100% Design Documentation

Lake Charlene Drainage Improvements
US 98 to Lake Joanne Drive

February 5, 2018

60% COUNTY COMMENT/RESPONSE

**WEIR AND GRADING PLAN
LAKE JOANNE DR.**

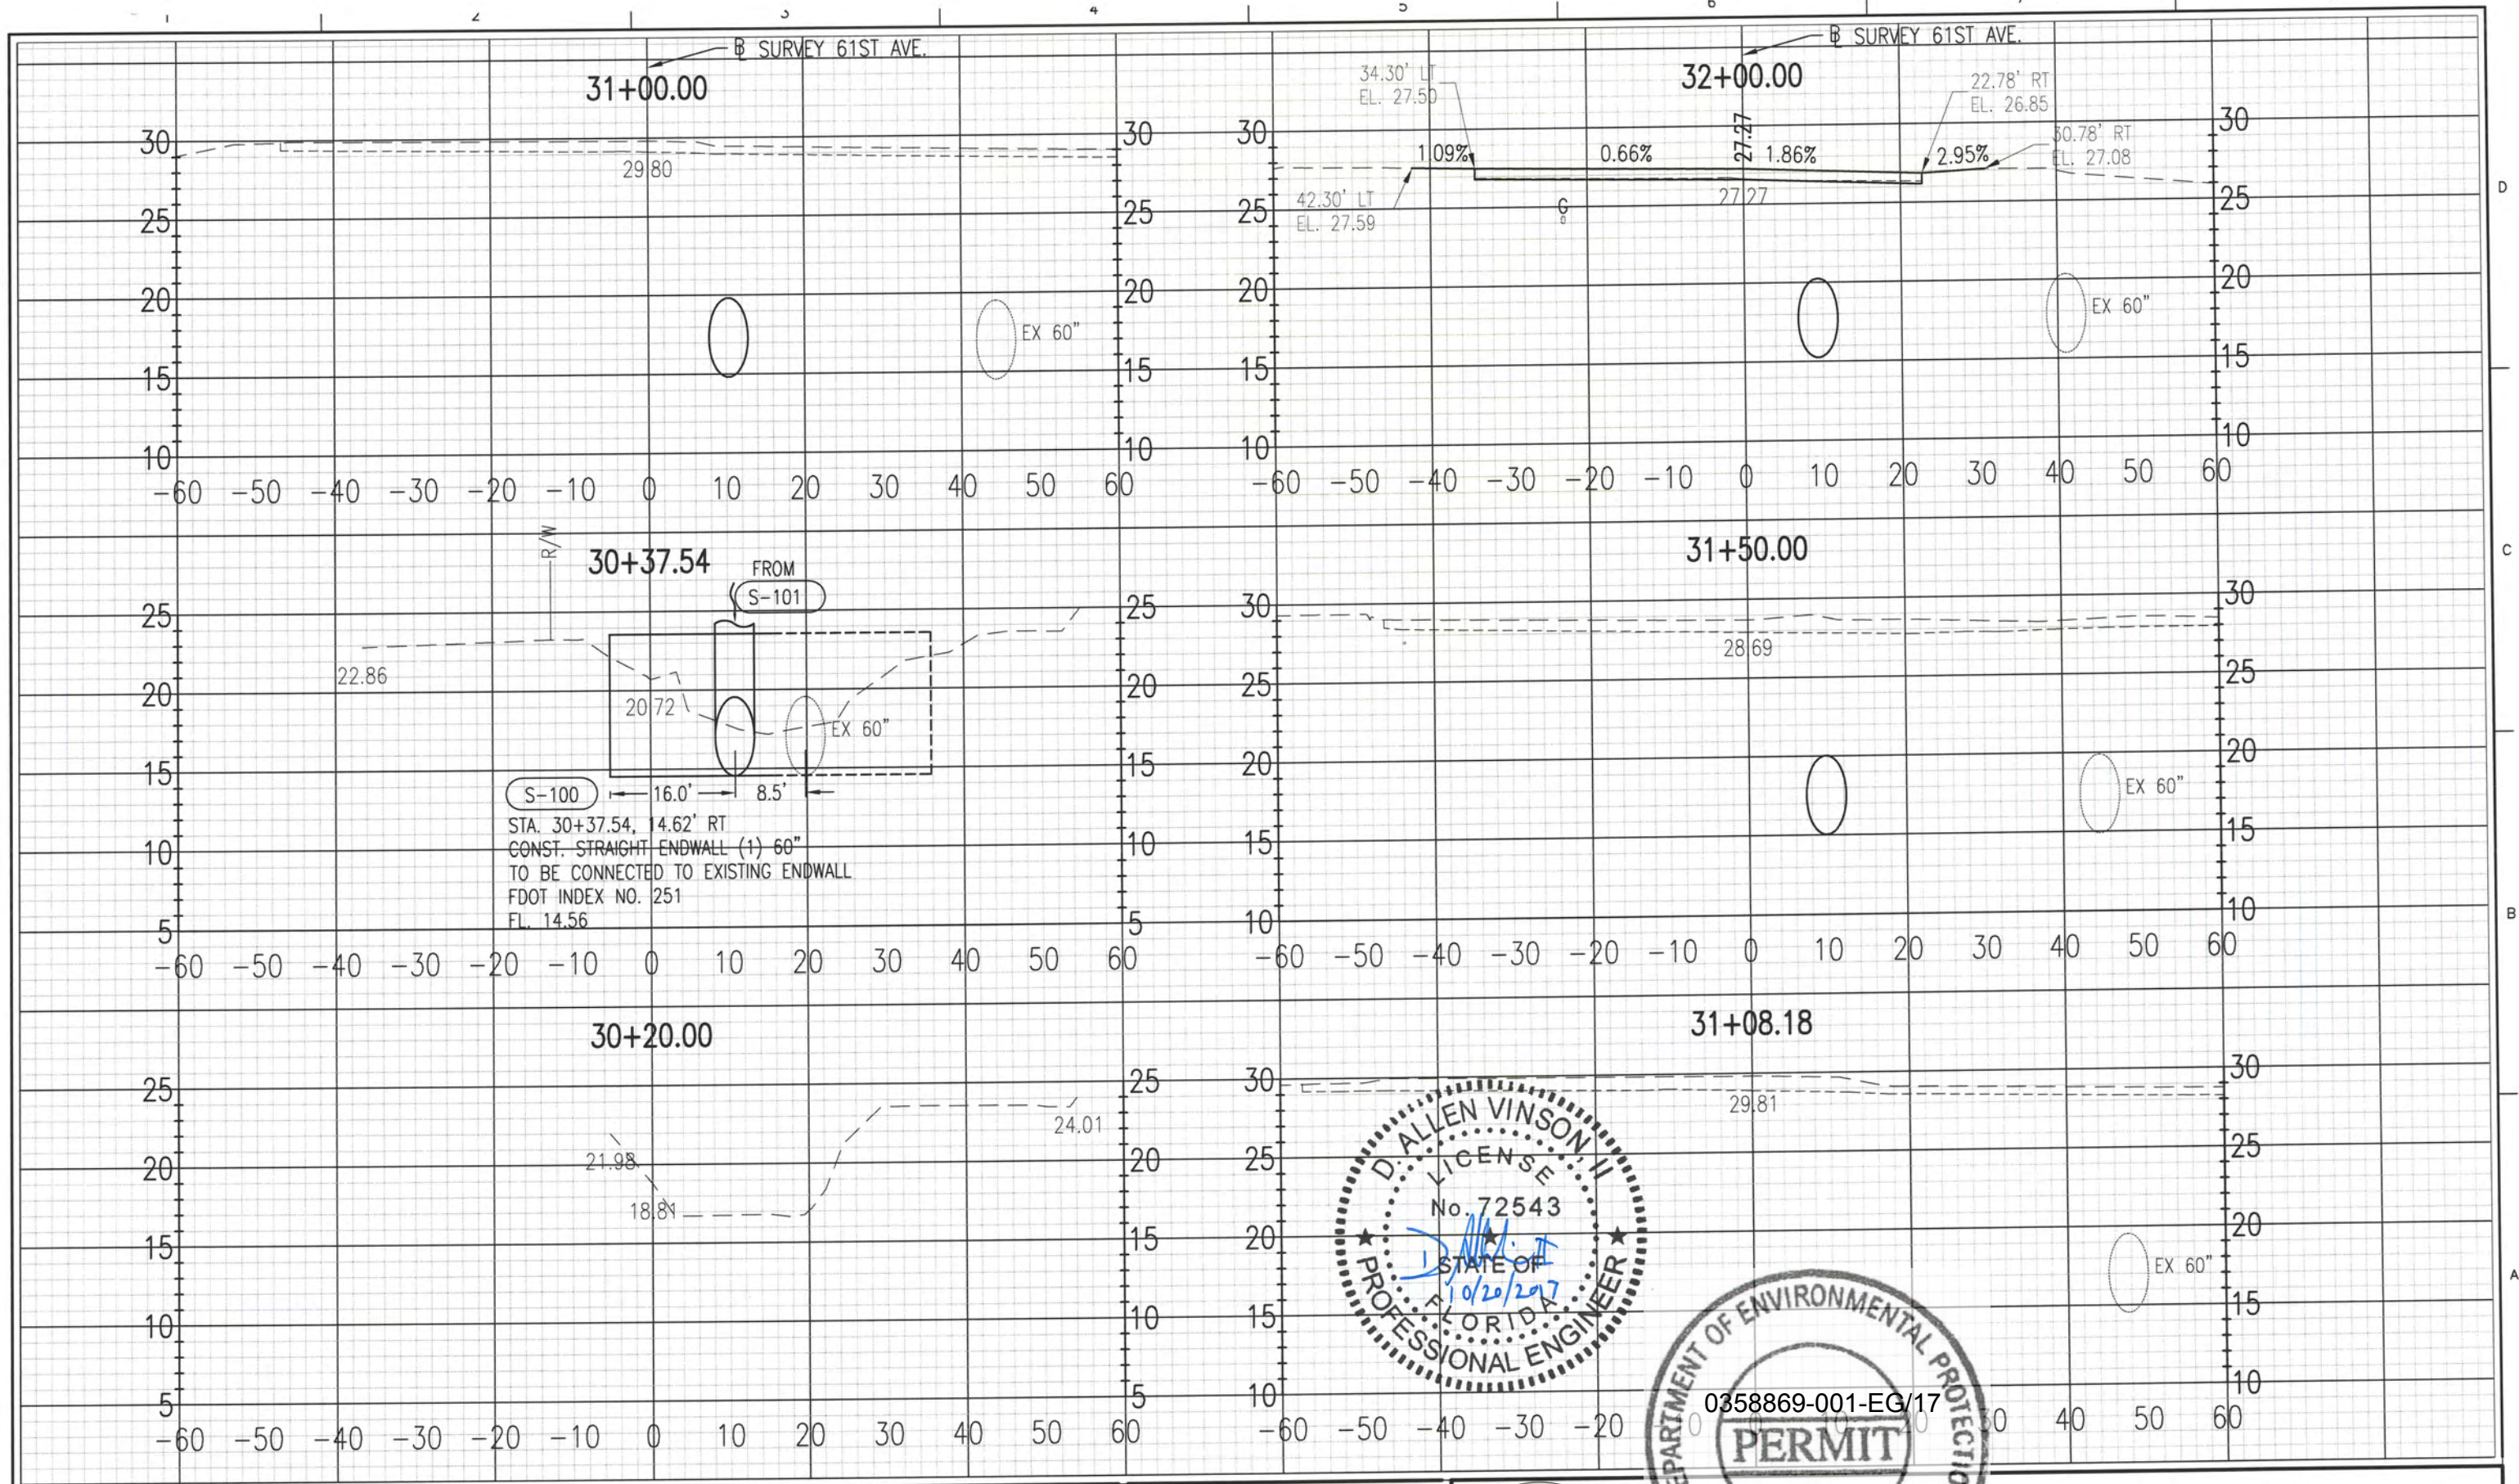
Comment No.	Sheet No.	Comment	Response	Designer Will Incorporate		
				YES	NO	Other
28		Sheet 13 – is there a way to design in an access ramp for maintenance?	Maintenance will have to be performed from the edges of the channel since the channel will be surrounded by sheet pile walls or concrete endwalls. The width of the weir structure was set at 30" to provide a maintainable space in the structure.		X	
29		Add misc. concrete in pay items.	If misc. concrete is required for some reason, it is suggested to added additional quantity to the concrete driveway pay item to cover. Otherwise there is no documented use.			Discuss
30		Add note due to water table collars will need to be poured for all connections.	This would be a tremendous expense for 60" concrete pipe. Please clarify.			Discuss
31		Consider adding water valve adjustments to bid tab.	Valve adjustments in the project limits are not expected.			N/A
